Kansas Department of Agriculture
Division of Water Resources
CHANGE: P/D WORKSHEET

RE: Filed Office Application for Change
Water Right, File No. 6389

CHANGE IN POINT OF DIVERSION WATER RIGHT, FILE NO. 6389

RE: Application for Change in Point of Diversion
Water Right, File No. 6389

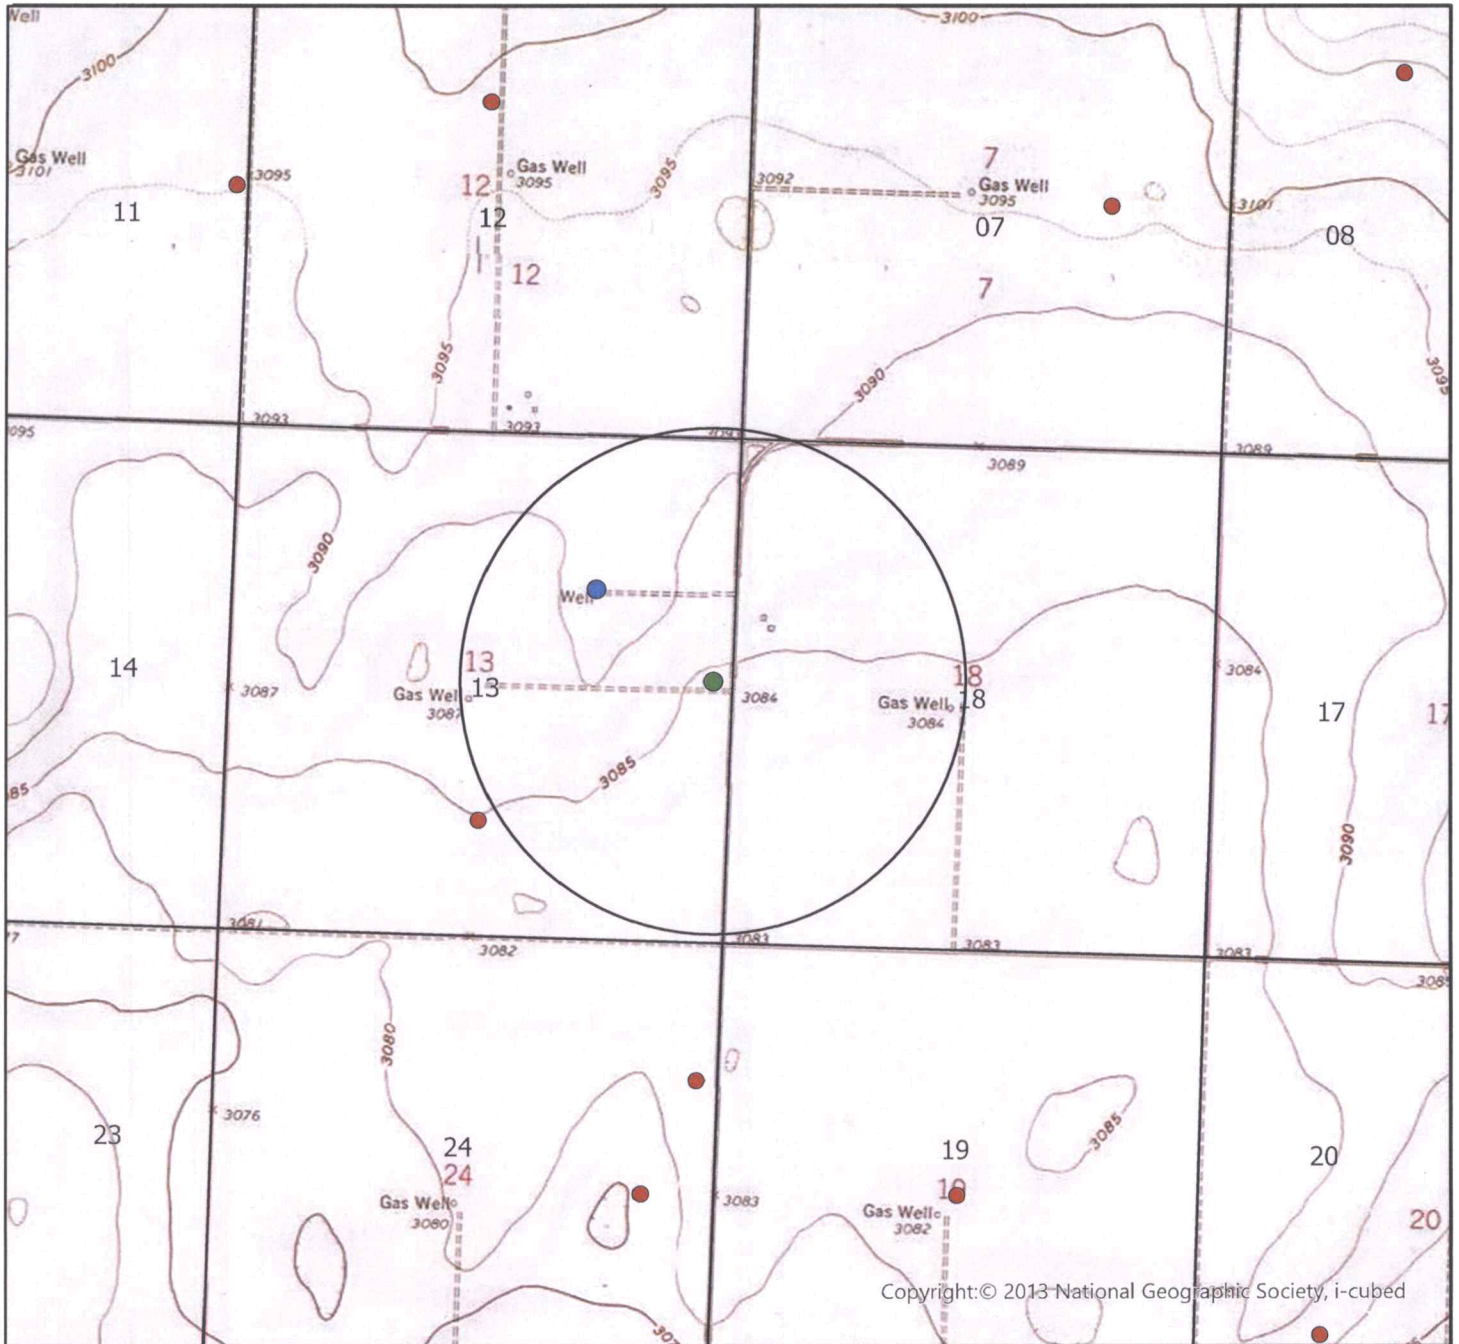
Authorized Point of Diversion
	Proposed Point of Diversion
	Permitted Water Right
	Domestic Well within 1/2 mile
	1/2 mile buffer

By signing below I agree that all wells, including domestic, and owners names and addresses within 1/2 mile of the proposed point of diversion have been shown on the map

GMD3 Change Review

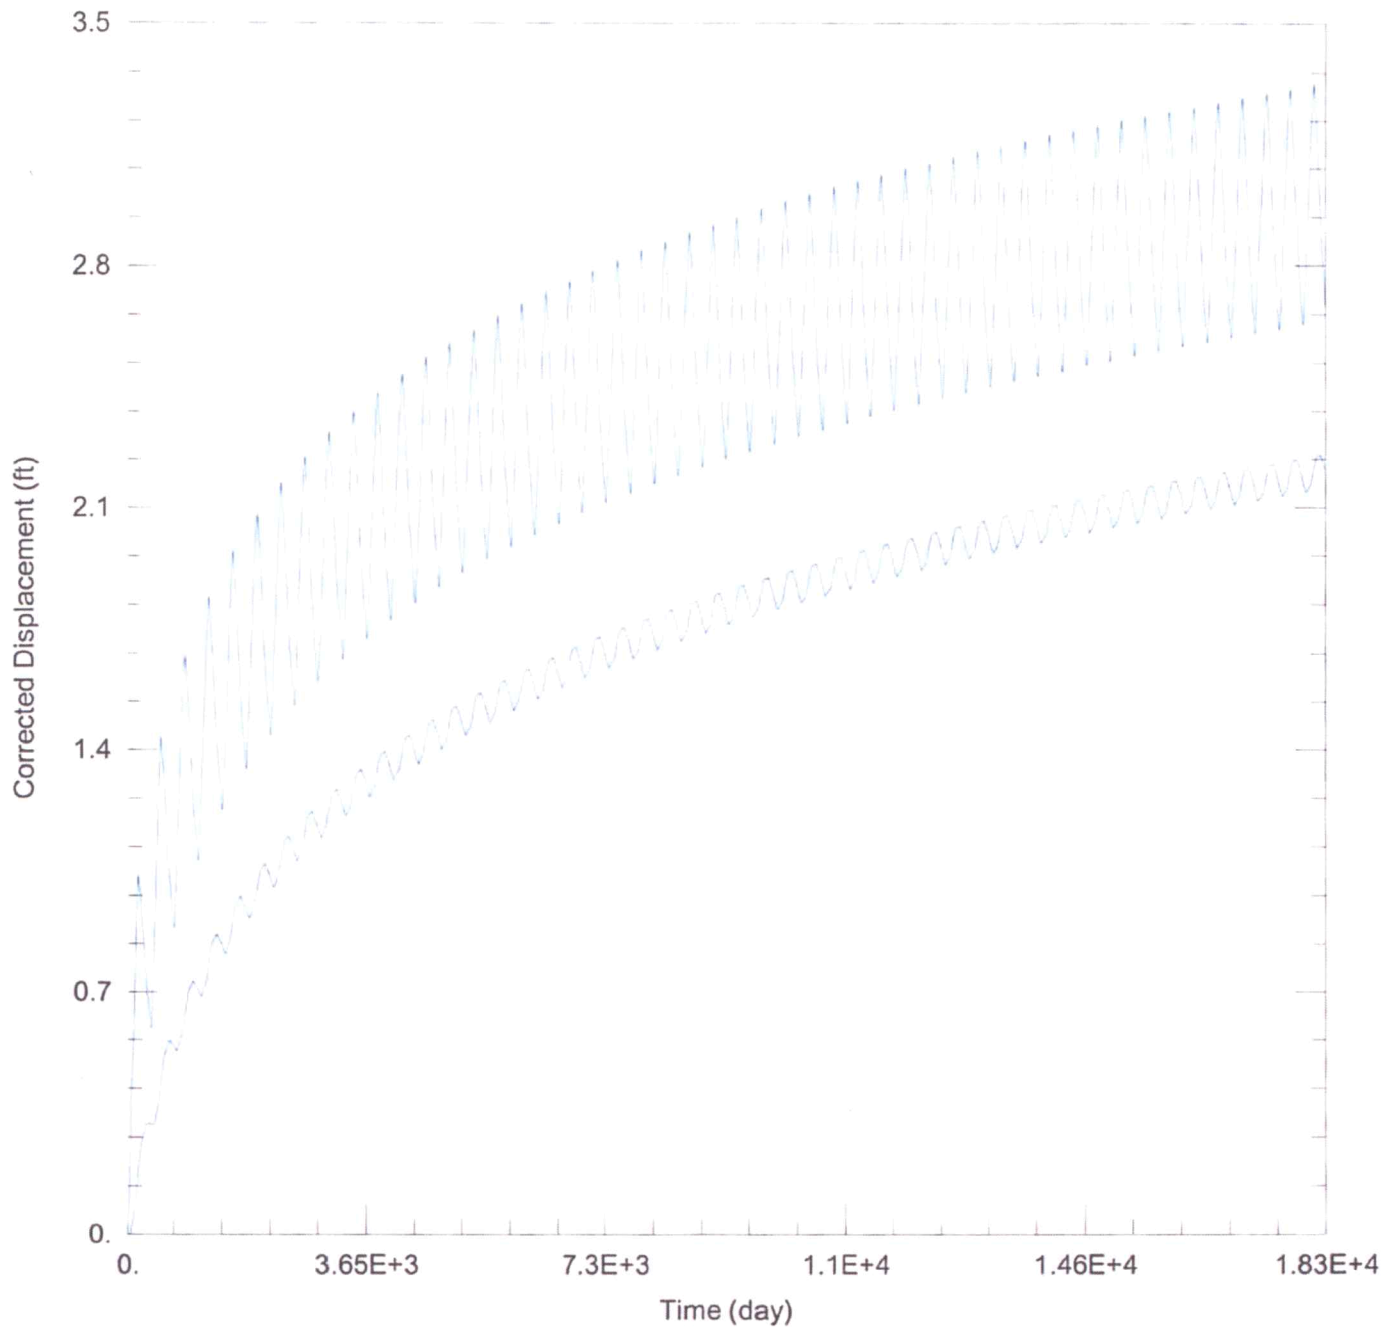
ft. North	ft. West	
Authorized PD	3674	1432	Sect 13-28-36
Proposed PD	2737	179	
Difference	937 s	1253 e	
$a^2 + b^2 = c^2$	877969	1570009	1564.602 foot move SE

Is a waiver needed: Move less than half mile. Minimum spacing to neighboring wells appears met. Analysis shows possible effects within guidelines, no critical wells.

Net drawdown does not exceed the drawdown allowance of 2.0 ft for any well within 1 mile of the proposed location. Therefore, critical well analysis is not necessary.

Recommendation: After review of all available information, appears current area rules are met. Staff therefore recommends approval of the application.

The proposed move is likely to create minimal effects on neighboring wells and appears unlikely to cause impairment. Any concerned neighbors should contact GMD3 at (620) 275-7147 or the Division of Water Resources at (620) 276-2901.
